UNITED STATES PATENT AND TRADEMARK OFFICE

APPLICATION NO.	FILING DATE	FIRST NAMED INVENTOR	ATTORNEY DOCKET NO.	CONFIRMATION NO.
10/563,359	07/19/2006	Jari Rasanen	0696-0227PUS1	8787

Office Action Summary	Application No. 10/563,359	Applicant(s) RASANEN ET AL.	
	Examiner BLAINE G. NEWAY	Art Unit 4133

DETAILED ACTION

Figure 1

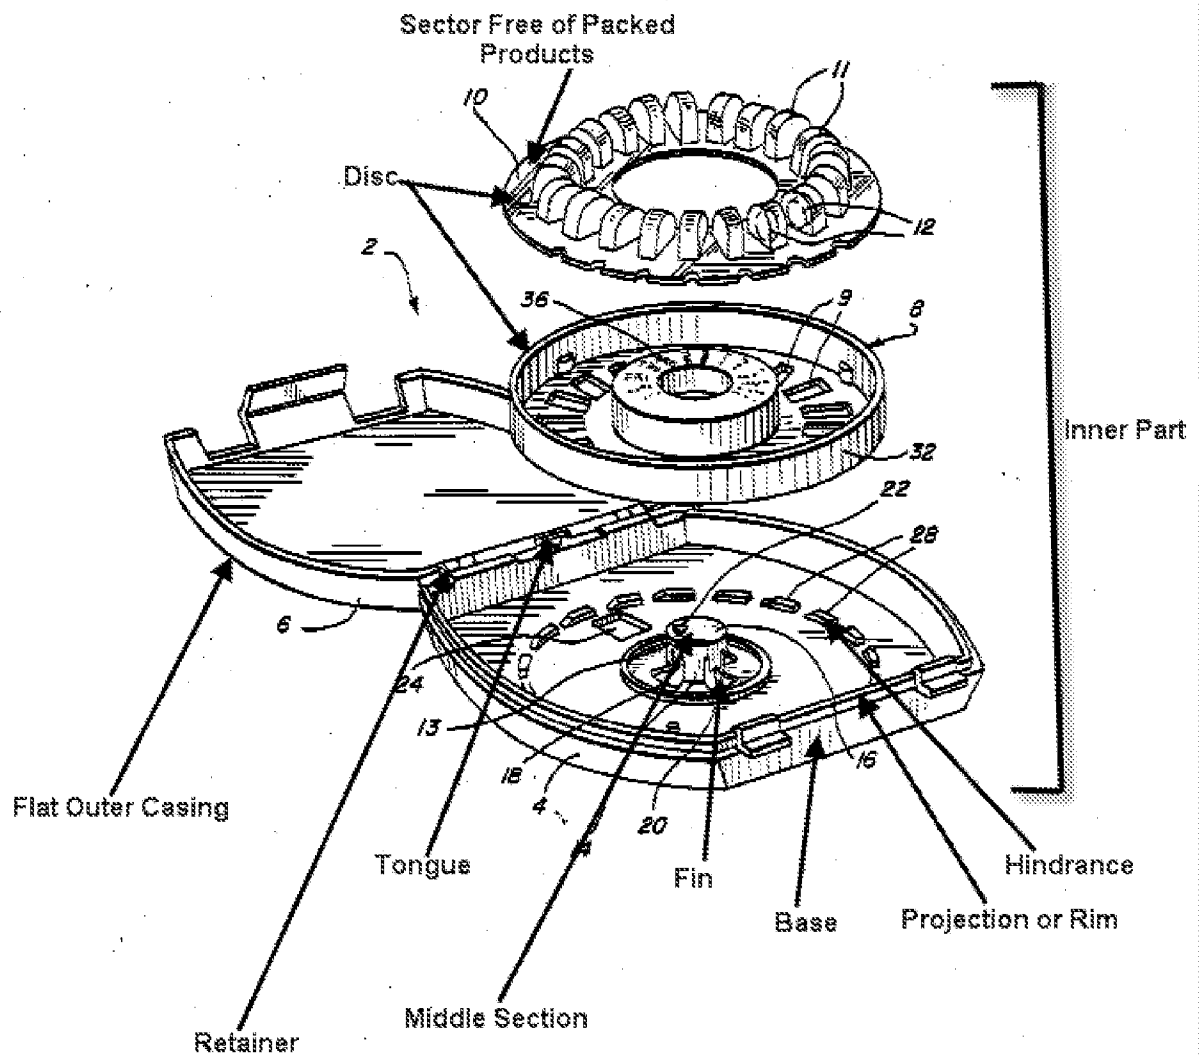
Regarding claim 1, Tump discloses an encapsulated blister package having a flat outer casing (6) open at least from one side, and an at least partly

extractable inner part (that is available, obtainable or removable by opening the casing) having a disc formed as a blister package fitted rotatably onto a base (4), which has an outlet opening (24) below the disc so that products (12) brought to the opening by rotating the disc can be released from the disc by pressing the respective blister (11) and removed from the package through opening (24) (See marked up figure 1).

Regarding claim 2, Tump further discloses the casing (6) and/or the inner part is provided with a retainer, preventing the inner part from becoming loose from the casing (See marked up figure 1).

Regarding claim 4, as best understood in light of the rejection under 35 U.S.C. 112, second paragraph made in this action, Tump further discloses the disc containing individual products (12) arranged to form an arc of a circle or a ring so that they can be brought to the outlet opening (24) one at a time by rotating the disc (See marked up figure 1).

Regarding claim 7, Tump discloses the base being provided with a longitudinal outlet opening (24) extending in the direction of the radius of the disc (See marked up figure 1).

Regarding claim 9, Tump discloses the disc having a sector which is free of packed products and that in an unopened package the sector is located at or near the outlet opening (24) in the base (See marked up figure 1).

Regarding claim 10, Tump further discloses the disc articulated onto the base (4) from its middle section (22) (See marked up figure 1).

Regarding claim 11, Tump further discloses the extractable inner part having a base(4) and a projection extending from its side above the disc for keeping the disc in place on the base in an assembled configuration (See marked up figure 1).

Regarding claim 13, Tump further discloses the projection being formed as an annular rim encircling the circumference of the disc (See marked up figure 1).

Regarding claim 14, as best understood in light of the rejection under 35 U.S.C. 112, second paragraph made in this action, Tump further discloses the projection or rim having a tongue extending towards the center of the disc at which a blister in the disc is left under the rim (See marked up figure 1).

Regarding claim 16, Tump further discloses a tablet dispensing package made of flat sheets or panels or "packaging board" (See marked up figure 1).
